Nuclear Fuel Services, Inc.  
P.O. Box 337, MS 123  
Erwin, TN 37650

21G-03-0277  
GOV-01-55-04  
ACF-03-0363

October 23, 2003

**Subject: License Amendment Request for the Oxide Conversion Building and Effluent Processing Building at the BLEU Complex**

Figure 9.2

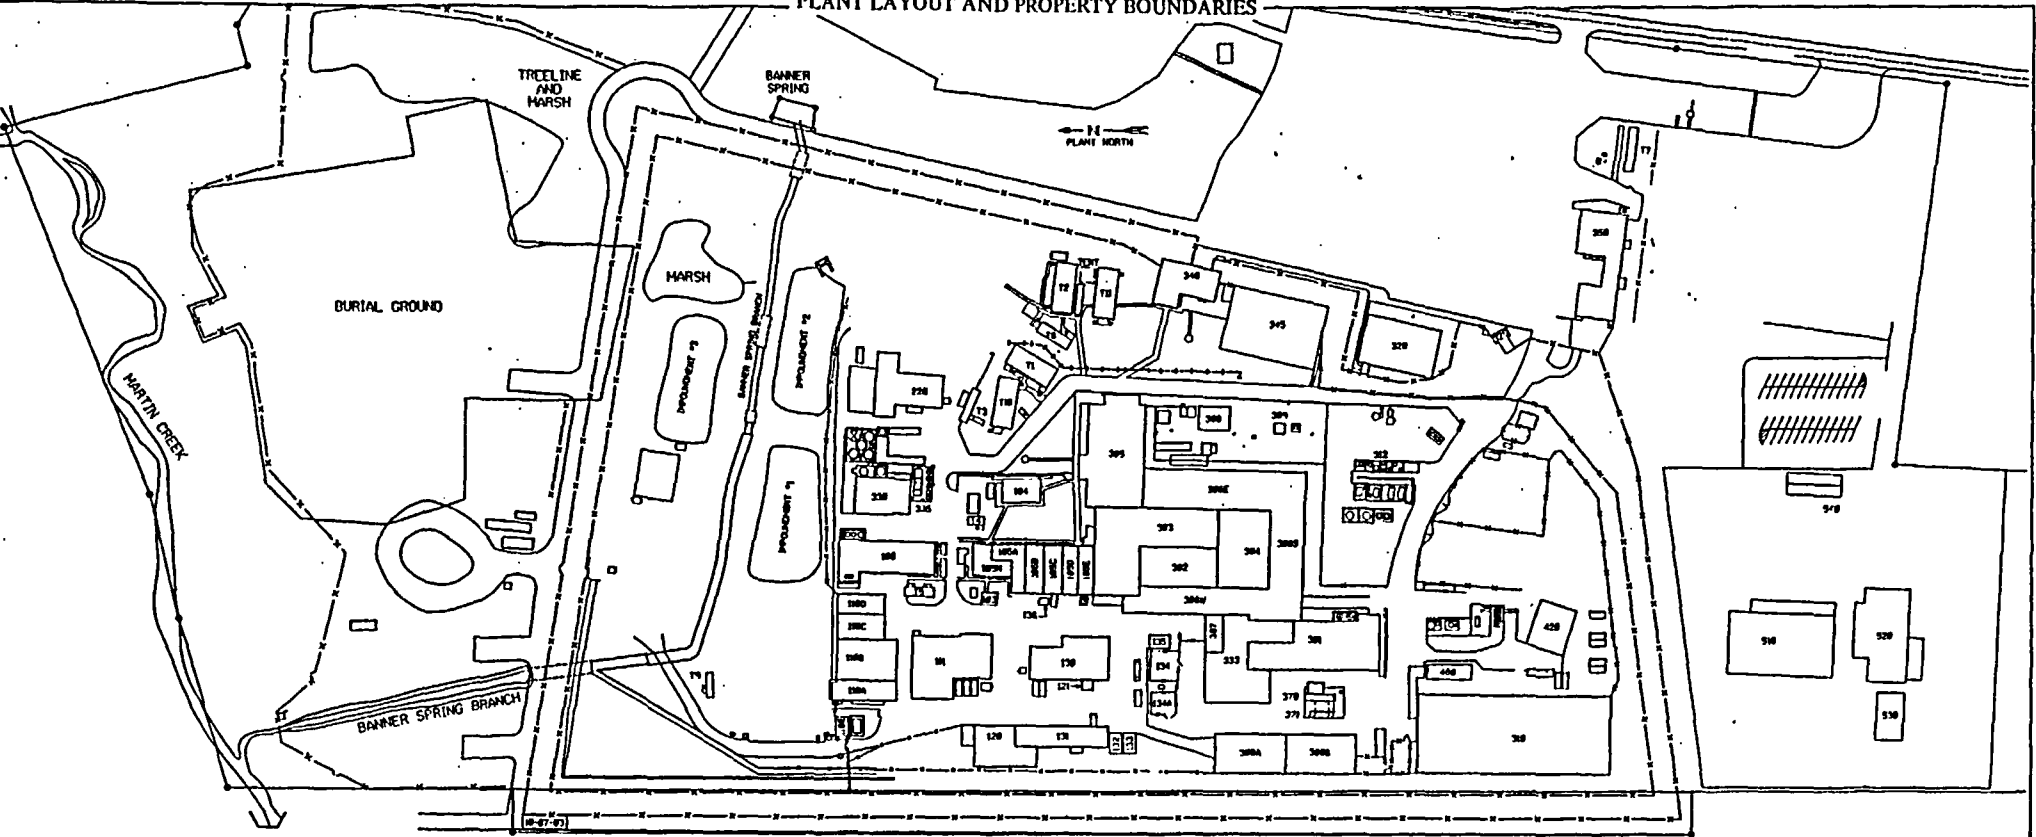
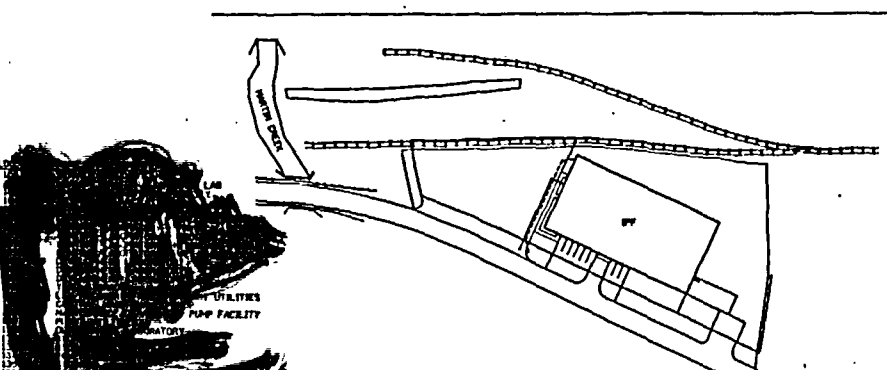
**Chapter 9, Section A - General Information:** Minor changes were required to add the OCB (Bldg. 520) and EPB (Bldg. 530) to Figure 9.2 *Plant Layout and Property Boundaries*.

Figure 10.1  
Site Layout with Building Descriptions

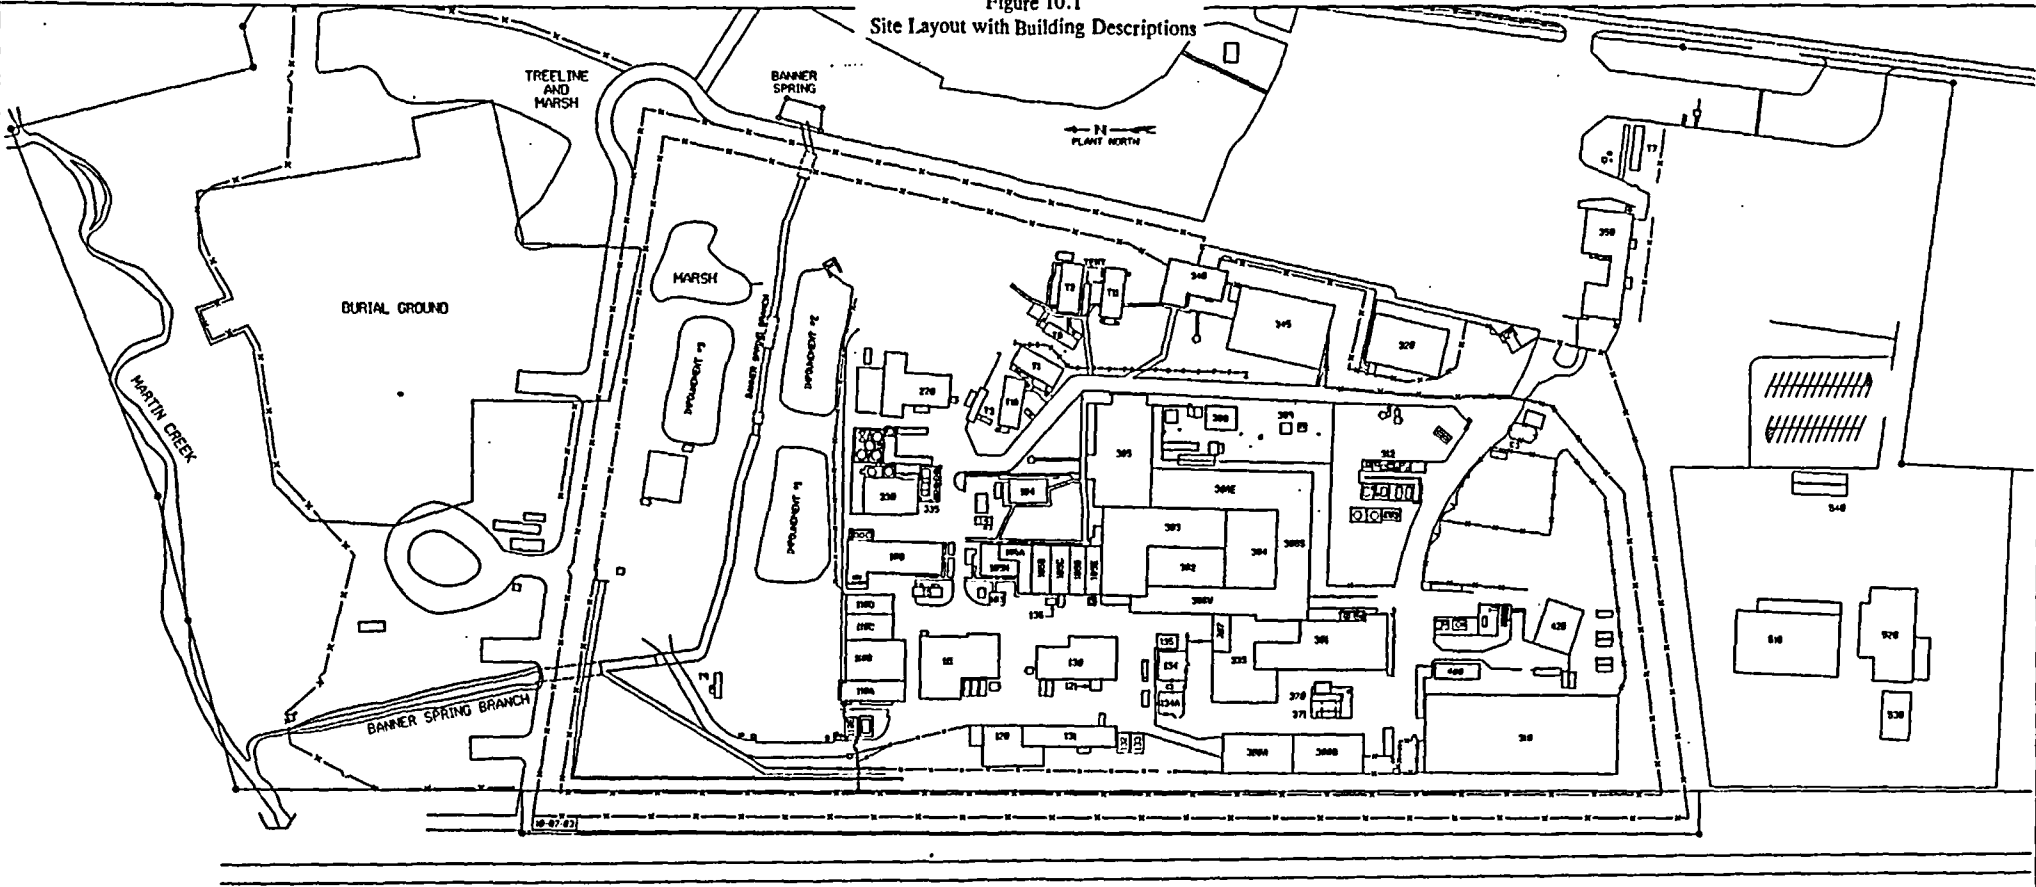
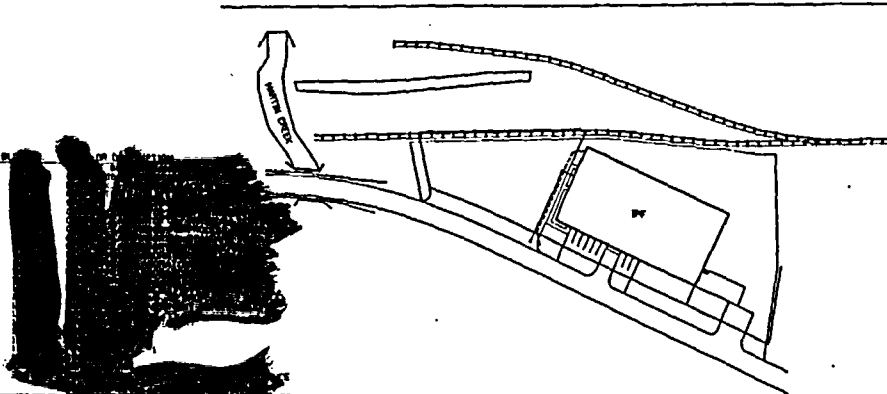
**Chapter 10, Section A - Site Layout:** Minor changes were required to add the OCB (Bldg. 520) and EPB (Bldg. 530) to Figure 10.1 *Plant Layout with Building Descriptions*.

Figure 10.12

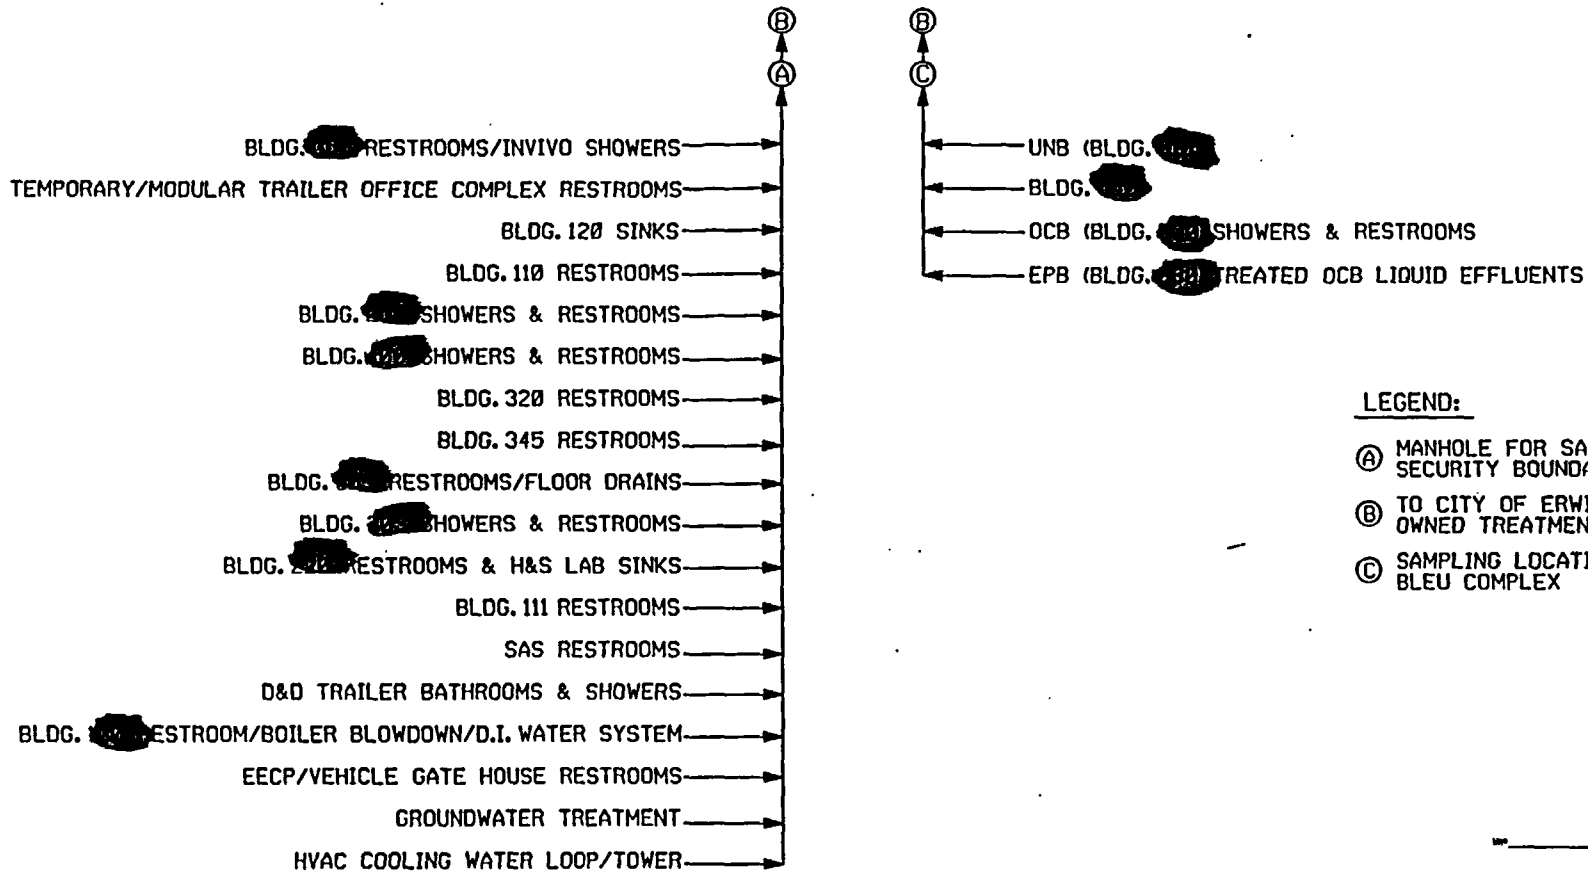
**Chapter 10, Section H – Waste:** Revisions to Figure 10.12 *N.F.S. Inputs to the Sanitary Waste Stream* were necessary to illustrate the inputs and sampling point for discharges to the sanitary sewer at the BLEU Complex.

Figure 12.1

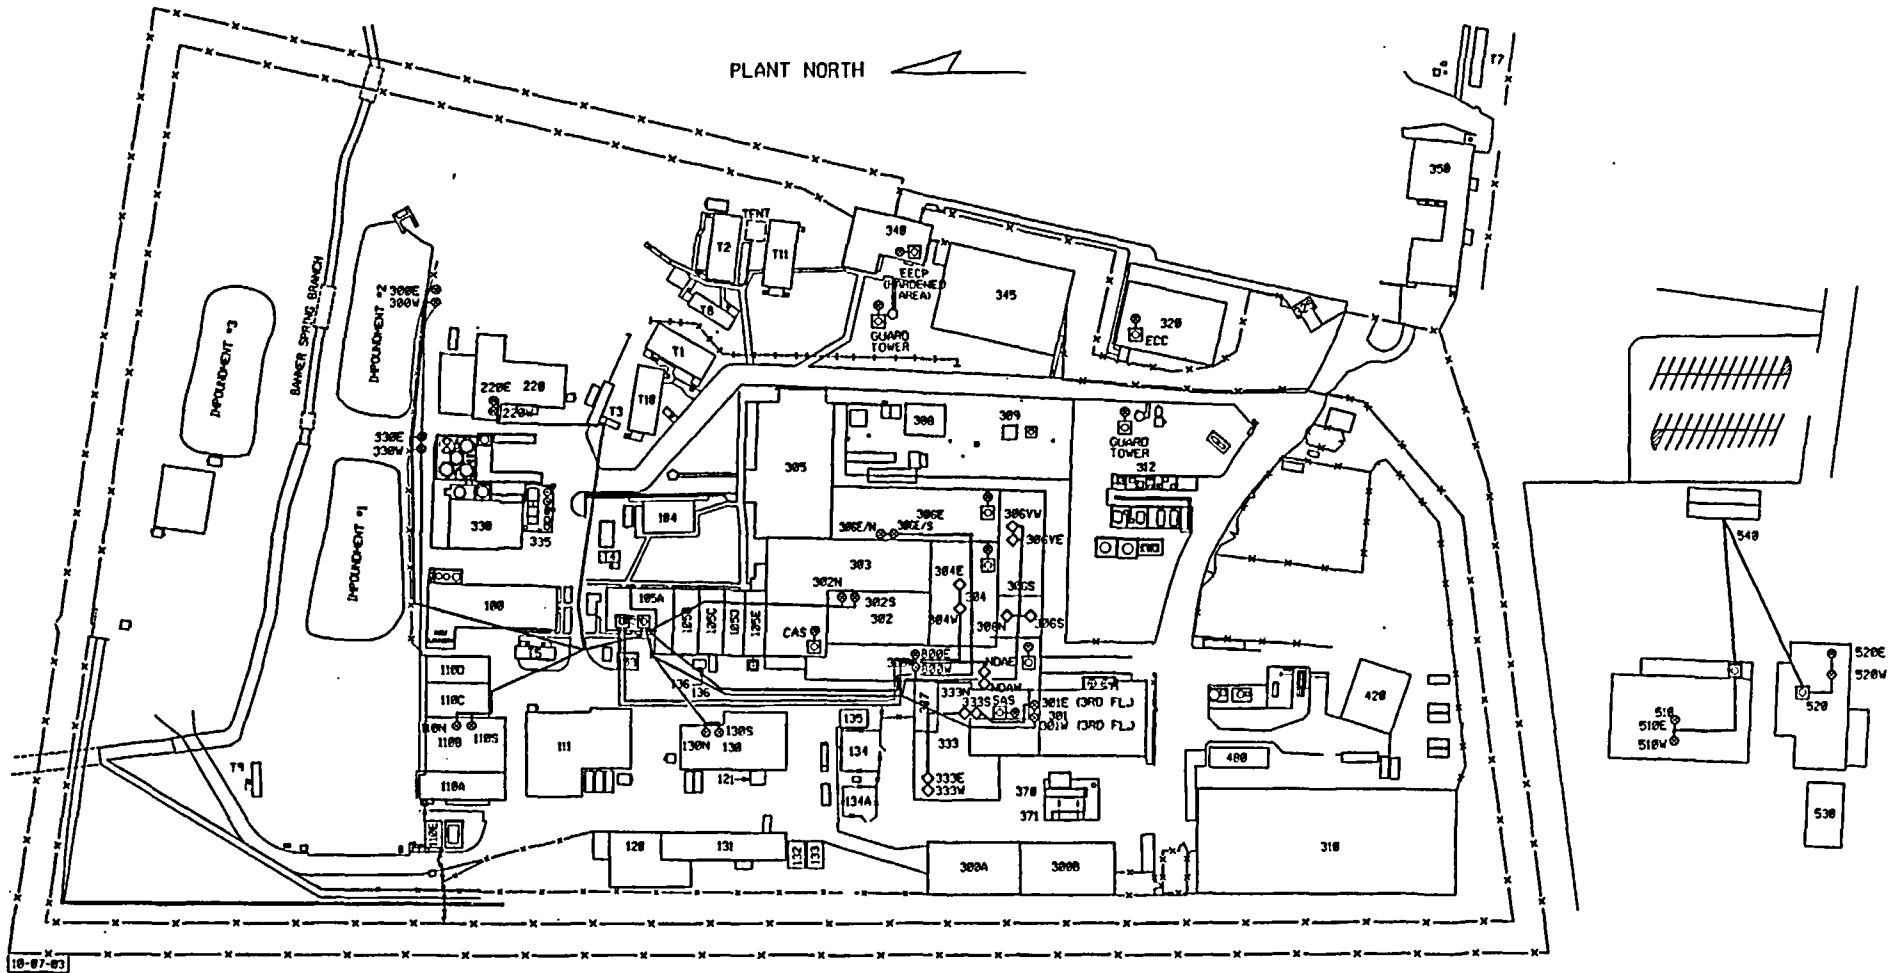
**Chapter 12, Section B – Instrumentation:** A minor change was required to Figure 12.1 *Criticality Detector Locations* reflecting the placement of nuclear criticality detectors at the OCB and EPB.

Figure 12.2  
Plant Areas Designated

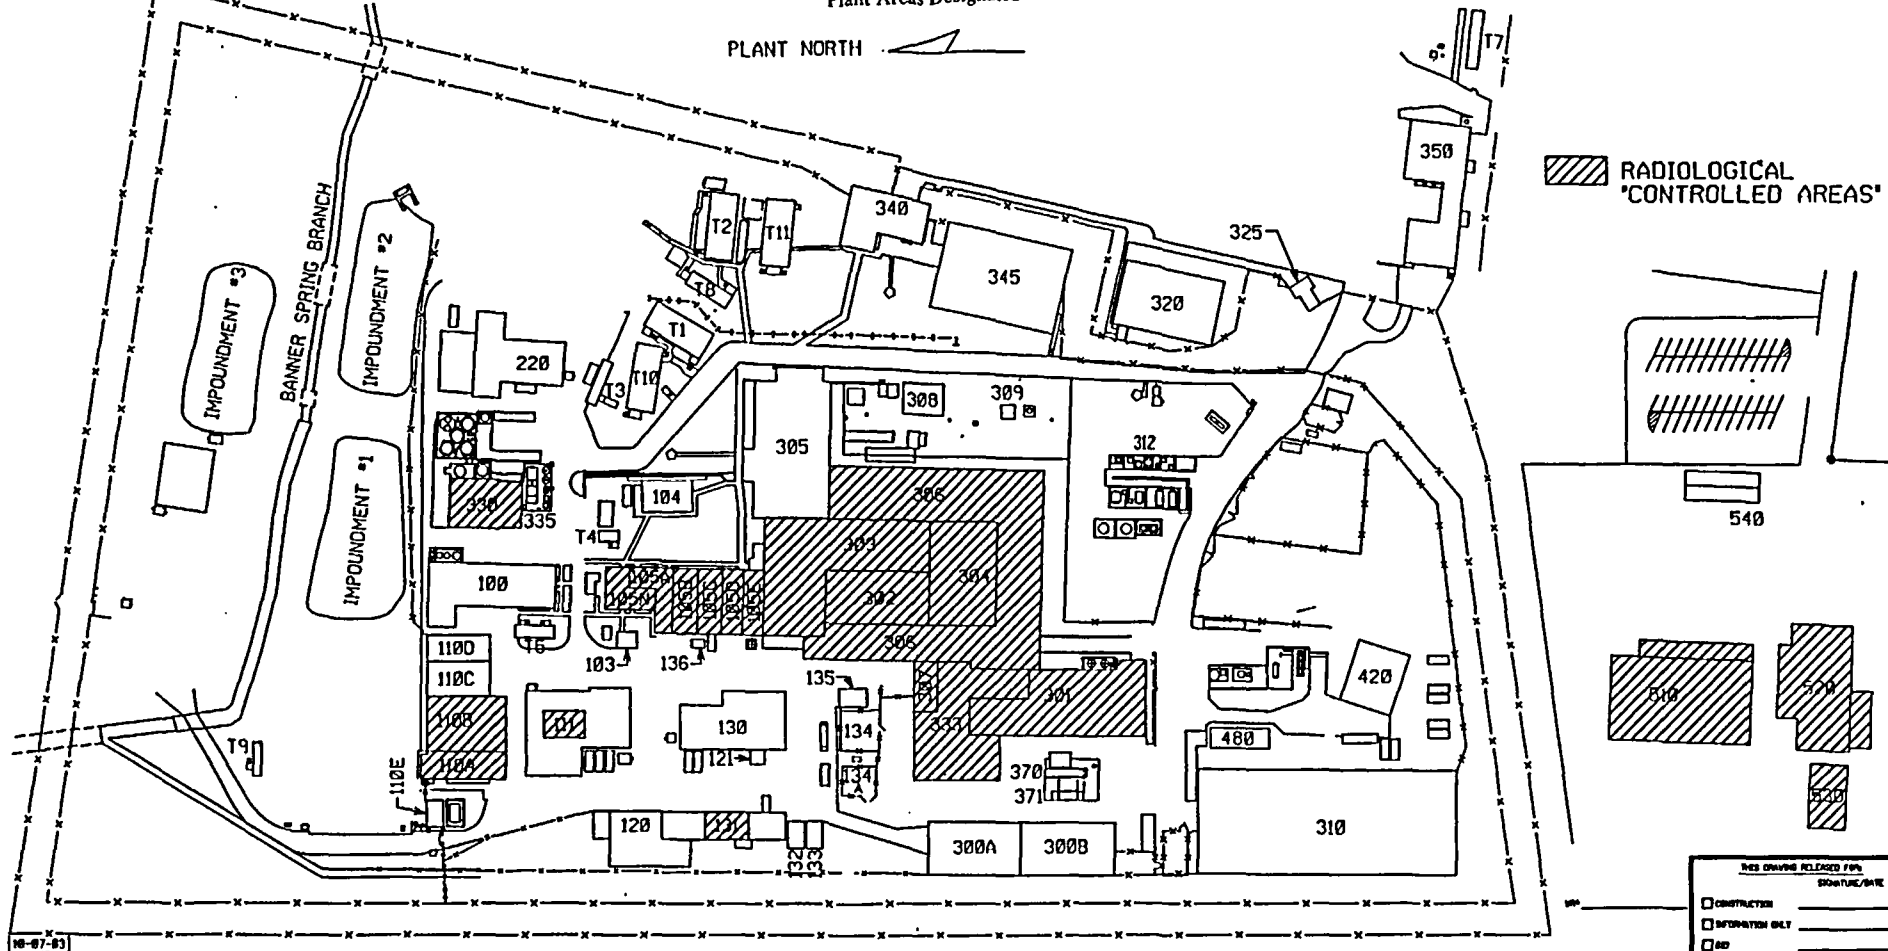
**Chapter 12, Section E- Exposure Control:** Revisions to Figure 12.2 *Plant Areas Designated* were necessary to reflect the locations of radiological controlled areas at the BLEU Complex.
